DATE: December 29, 2021

SUBJECT: ADDENDUM NO. 4 TO THE BIDDING DOCUMENTS FOR

**LOCKER ROOM RENOVATION  
EAST ST. LOUIS SENIOR HIGH SCHOOL  
EAST ST. LOUIS SCHOOL DISTRICT 189  
EAST ST. LOUIS, ILLINOIS  
HR Project # 280-0361**

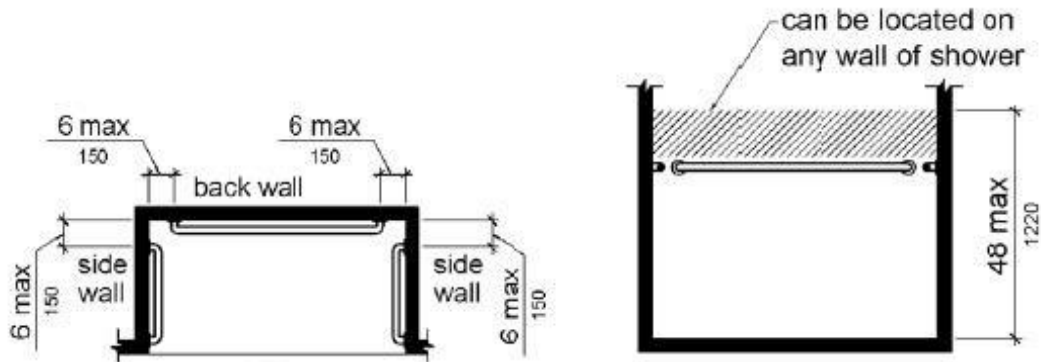
- b. **Question:** How do we differentiate Std fixtures from ADA? Plans do not indicate ADA.  
**Response:** ADA compliant fixtures are as follows:

MENS ATHLETIC RESTROOM AND SHOWER #105

- north shower, southeast toilet, southeast urinal & north sink.

MENS ATHLETIC RESTROOM AND SHOWER #101

- south shower, northeast toilet, northeast urinal & south sink.

WOMENS ATHLETIC RESTROOM AND SHOWER #111 & #113

- north shower, northwest toilet, & north sinks.

WOMENS ATHLETIC RESTROOM AND SHOWER #115 & #116

- south shower, northeast toilet, & north sinks.

MENS & WOMENS PE RESTROOM AND SHOWER #126 & #122

- west showers, east toilets, east urinal & west sinks.

## Battery Powered Exposed Sensor Flush Valve for Water Closets

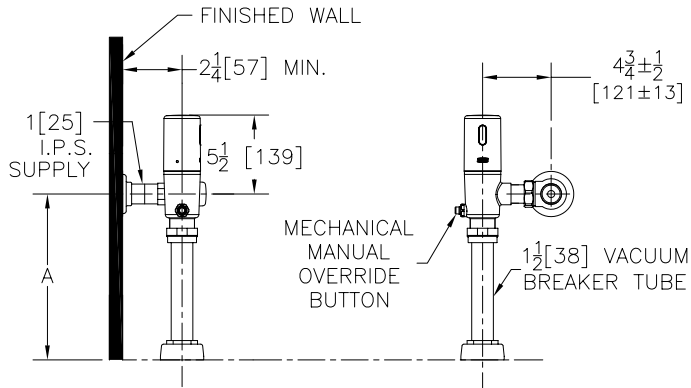
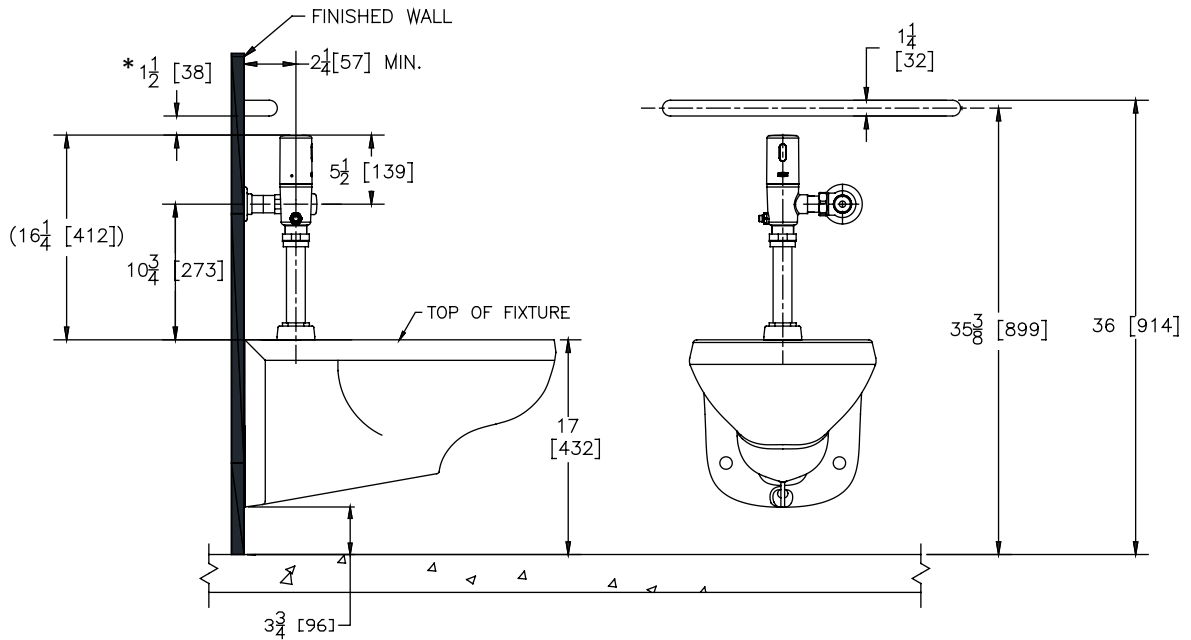
- d. **Question:** Sheet P-601, Toilet Valve, how do you access flush valve to change the batteries or service the valve?  
**Response:** Provide non-concealed flush valve, Attachment #3.

- e. **Question:** Why is Water Closet flush valve concealed & urinal flush valve exposed?  
**Response:** Provide non-concealed flush valve, Attachment #3.
